Michael Collins Architect LLP

6 Chaomans Letchworth
Job No. **188** Elevations East DD
as proposed

Stage: Stage 3
Status: **Non-material amendment**

East Elevation East DD as Proposed

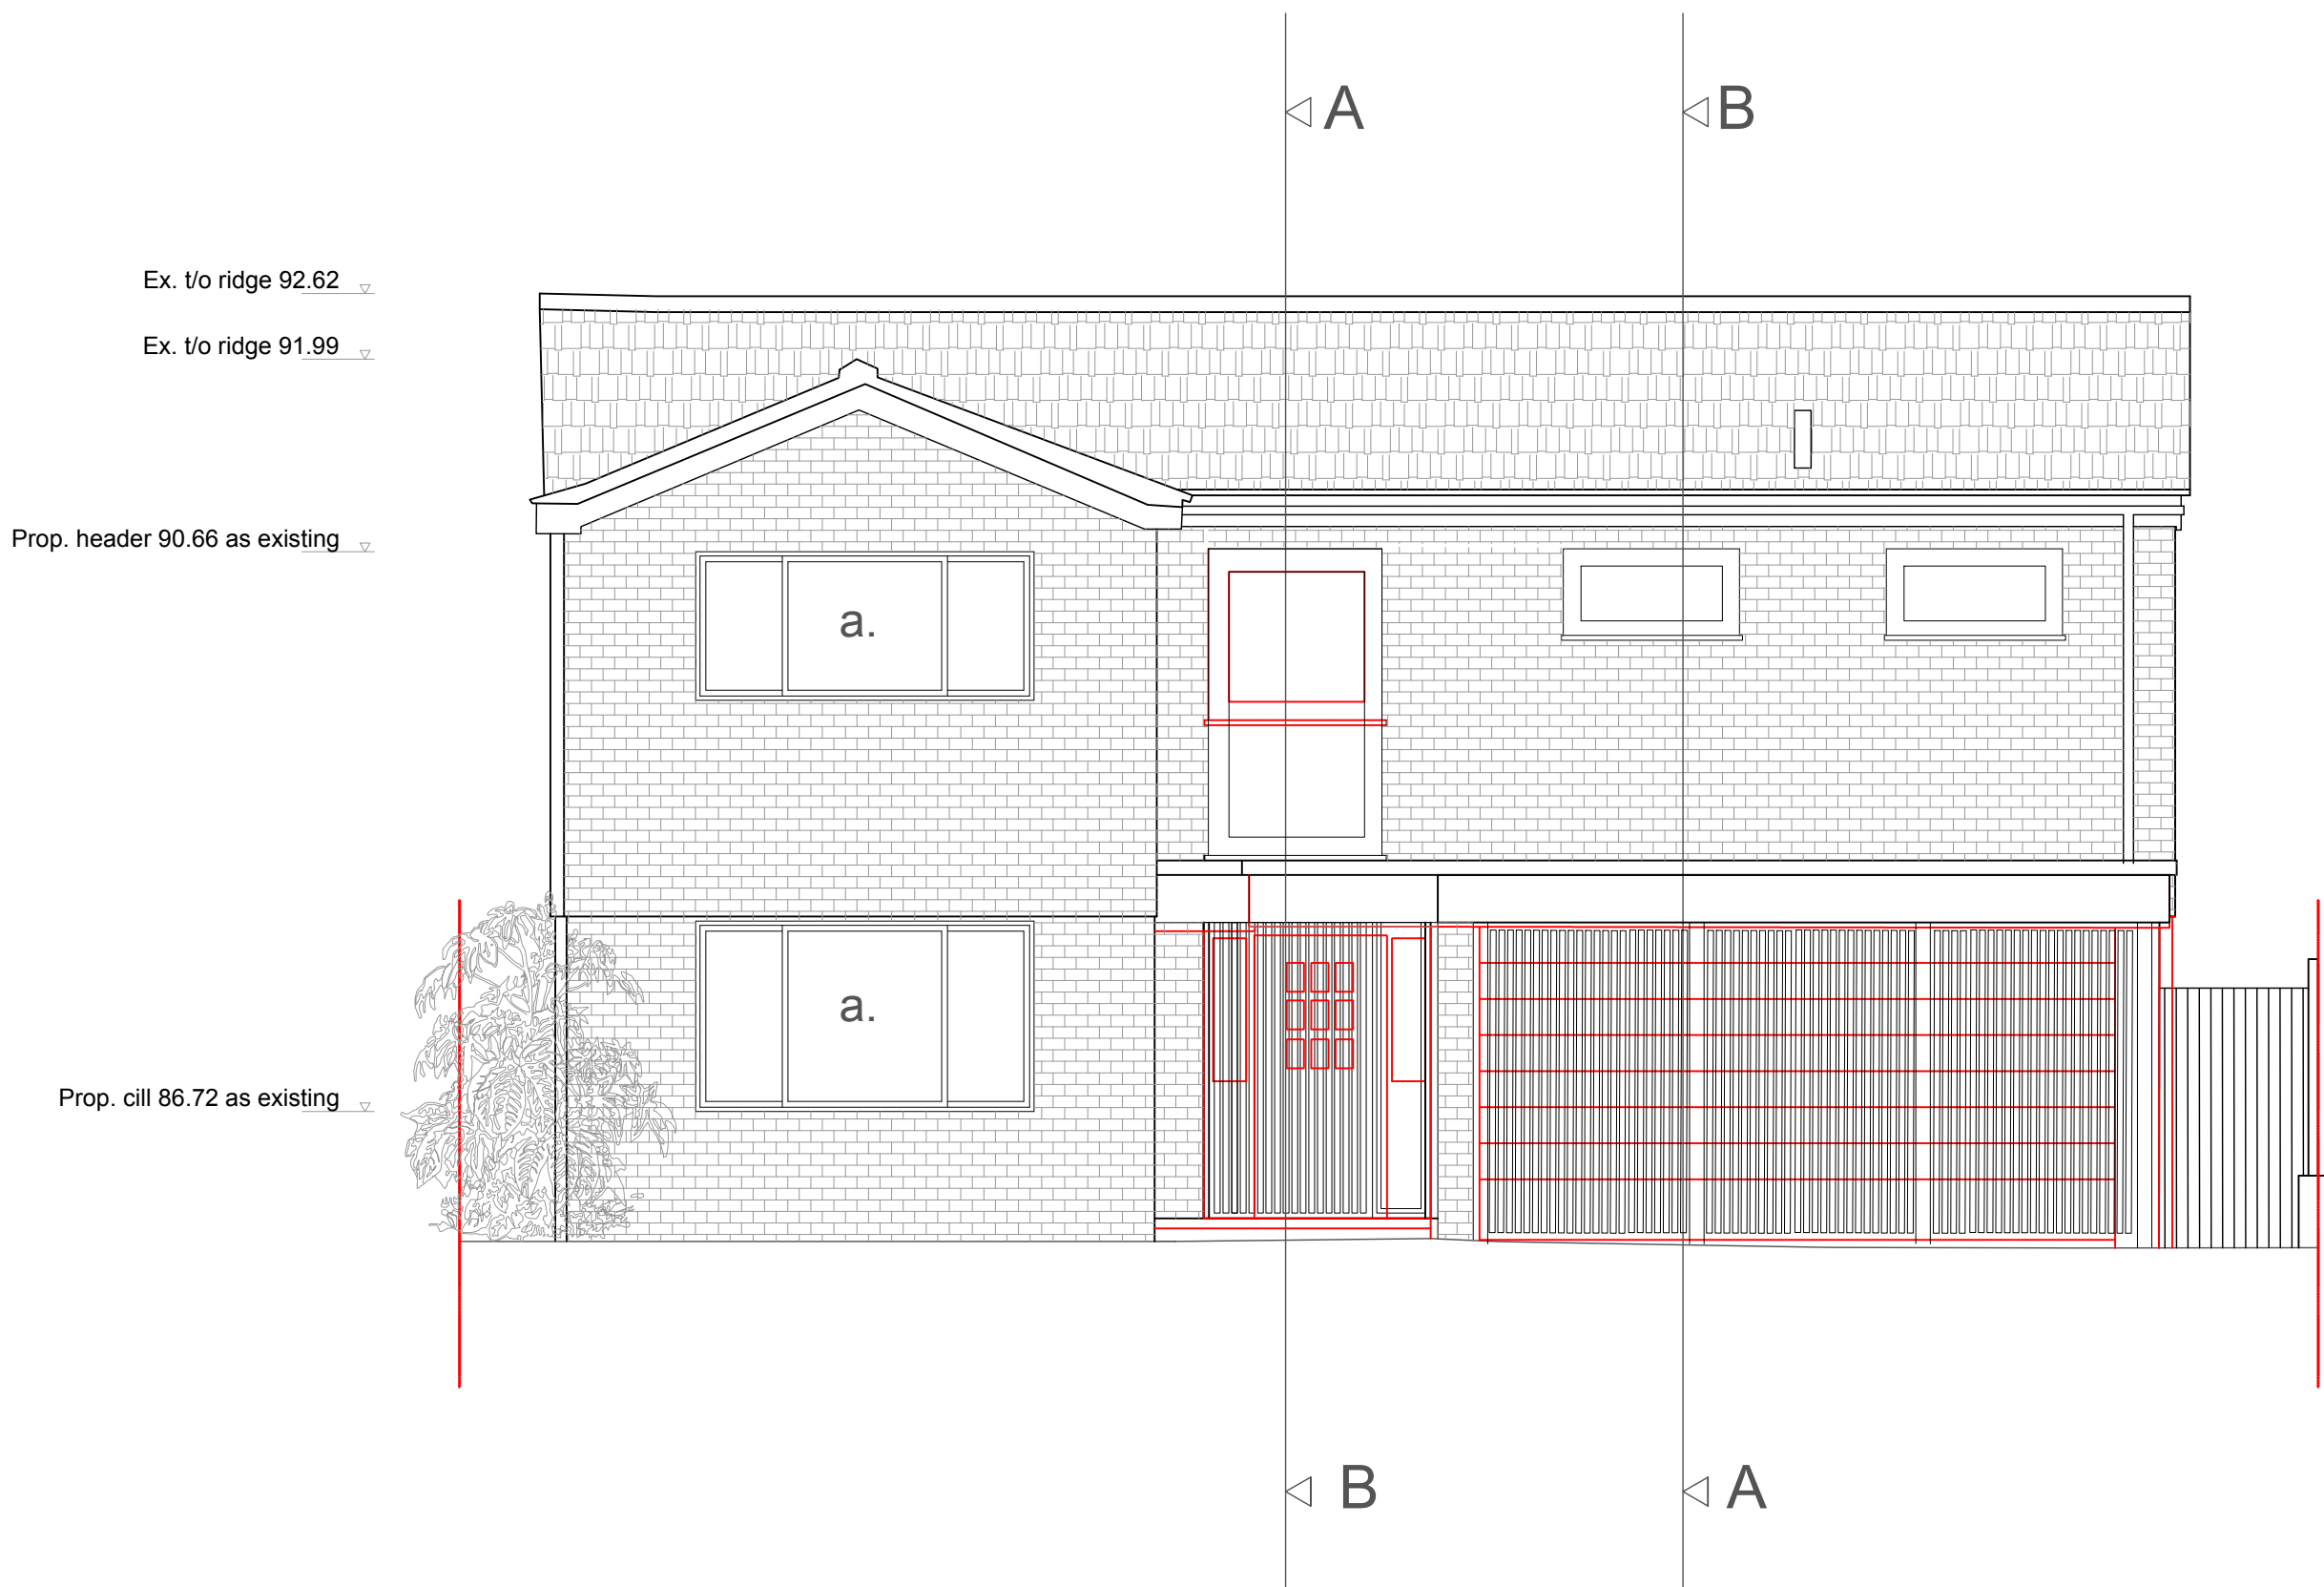
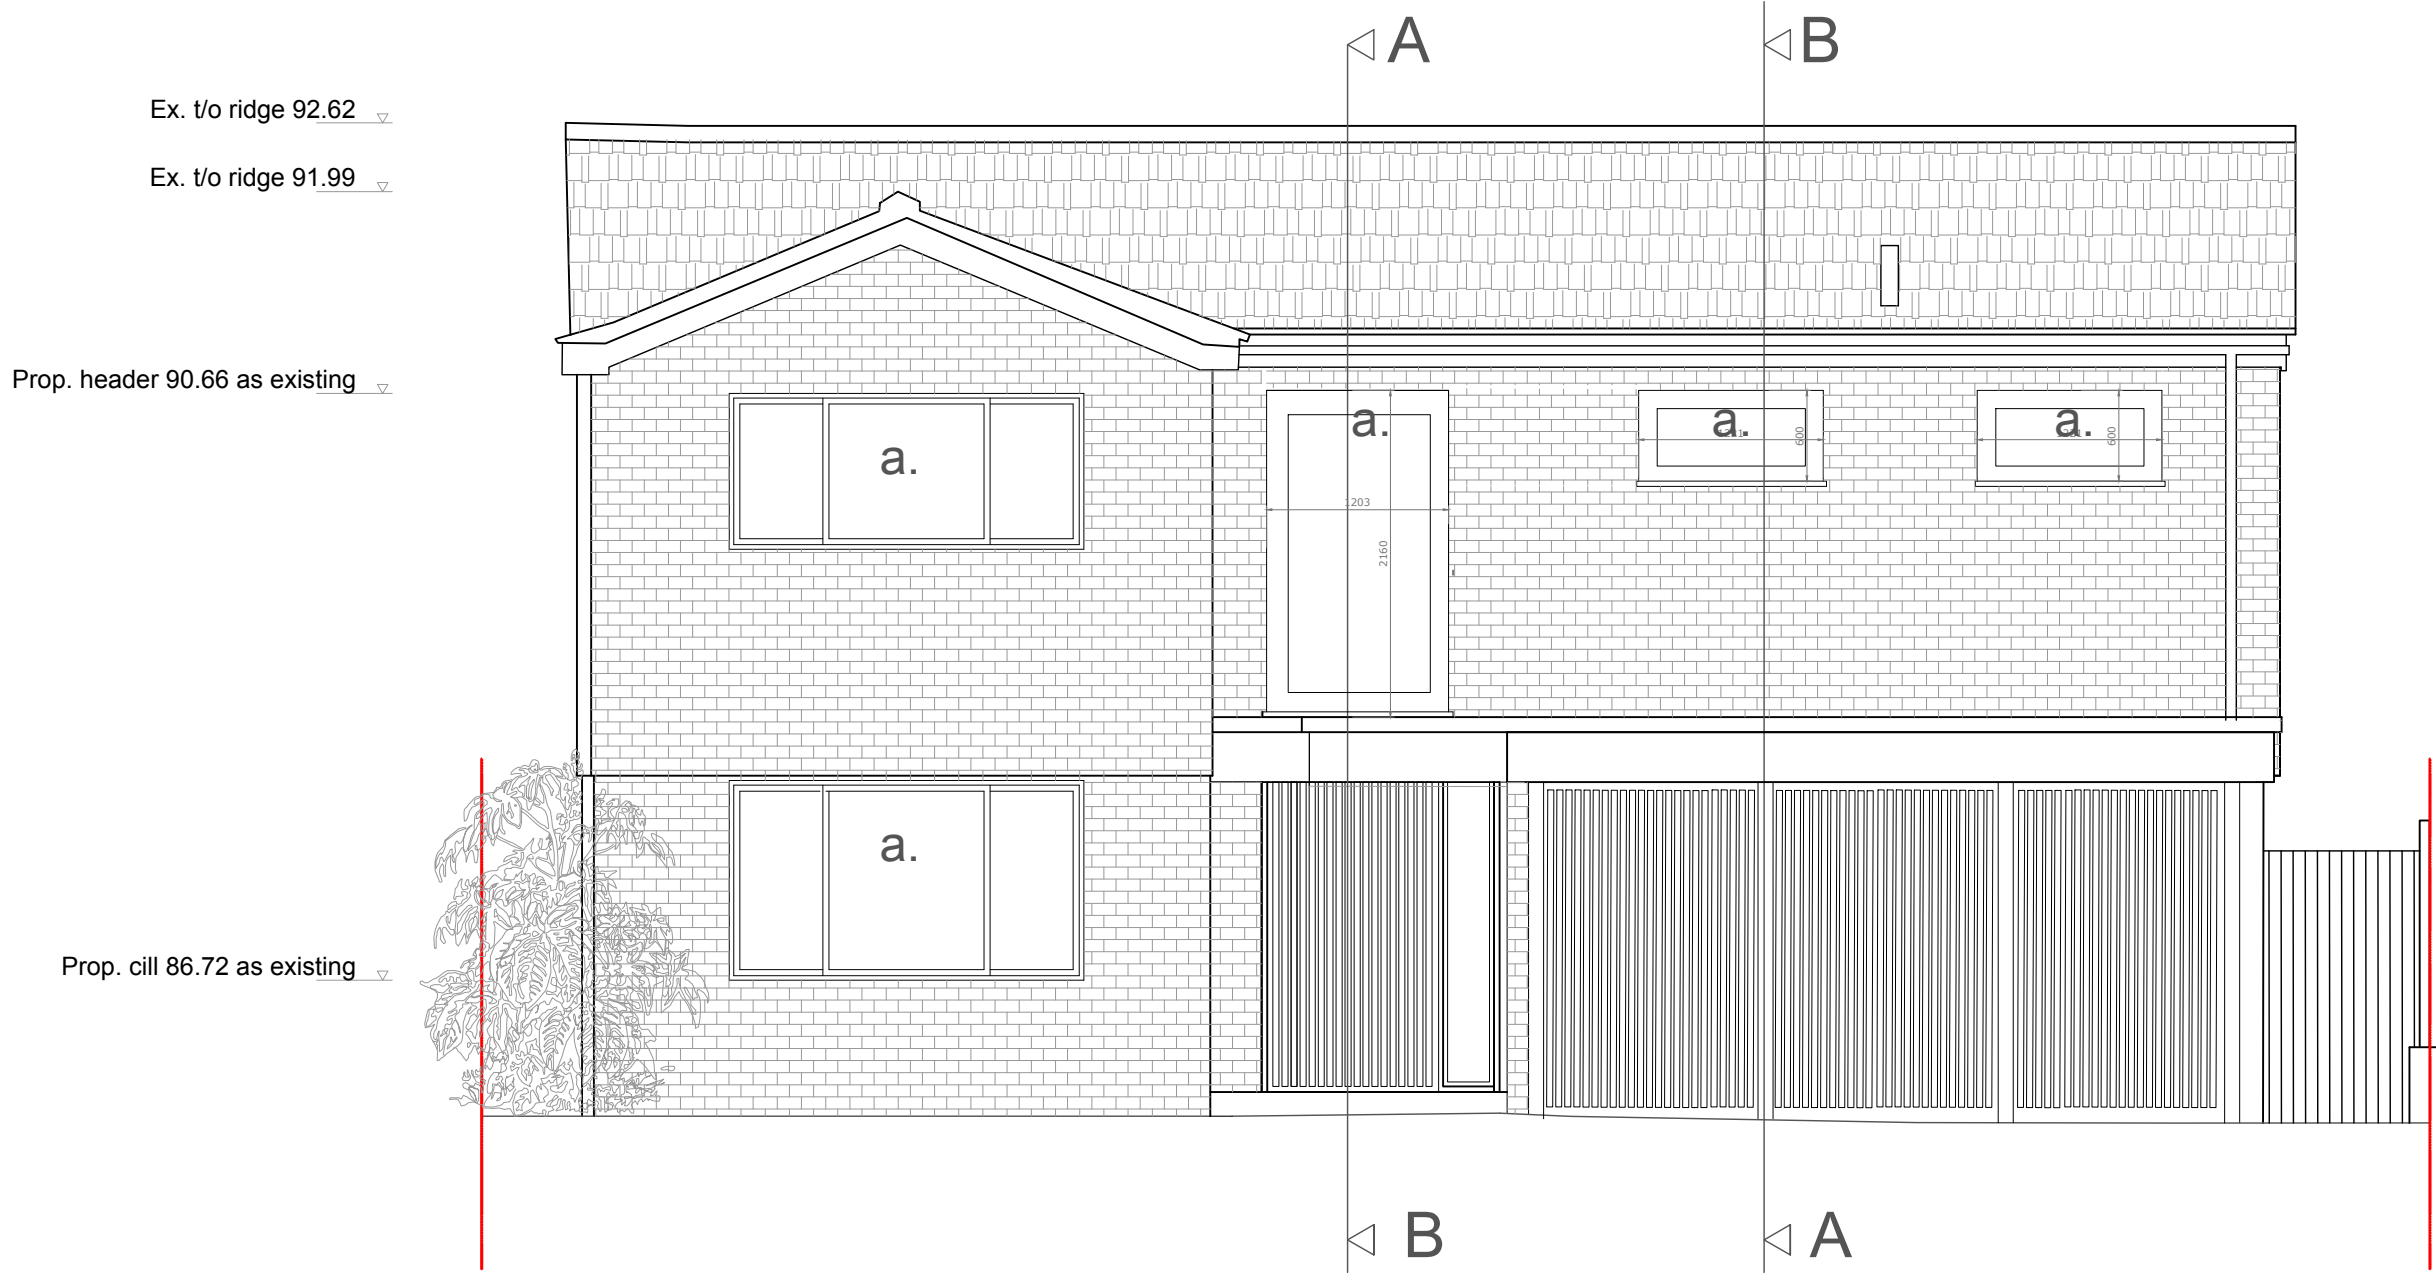
- a. Replace white UPVC existing windows with **aluminium** window - white
- b. New timber front porch door with fixed glazing panel
- c. Existing brick wall
- e. New rooflight
- f. New aluminium RAL 7013 cladding frame**
- g. New **iroko** timber cladding and louvered screen
- h. Existing side gate
- i. New brick wall to match existing
- j. New slimline aluminium sliding doors bronze anodised
- k. New flat roof
- l. Widflower flat roof
- m. Aluminium flashing **RAL 7013**
- n. White fascia
- o. New door - wood
- p. New slimline aluminium windows **RAL 7013**
- q. Oak frame for window
- r. New PV panels
- s. New **white aluminium** window white to match the adjacent windows (**frosted glazing**)
- t. Replace existing UPVC windows with aluminium window RAL 7013**
- u. Seamless glazed balustrade**
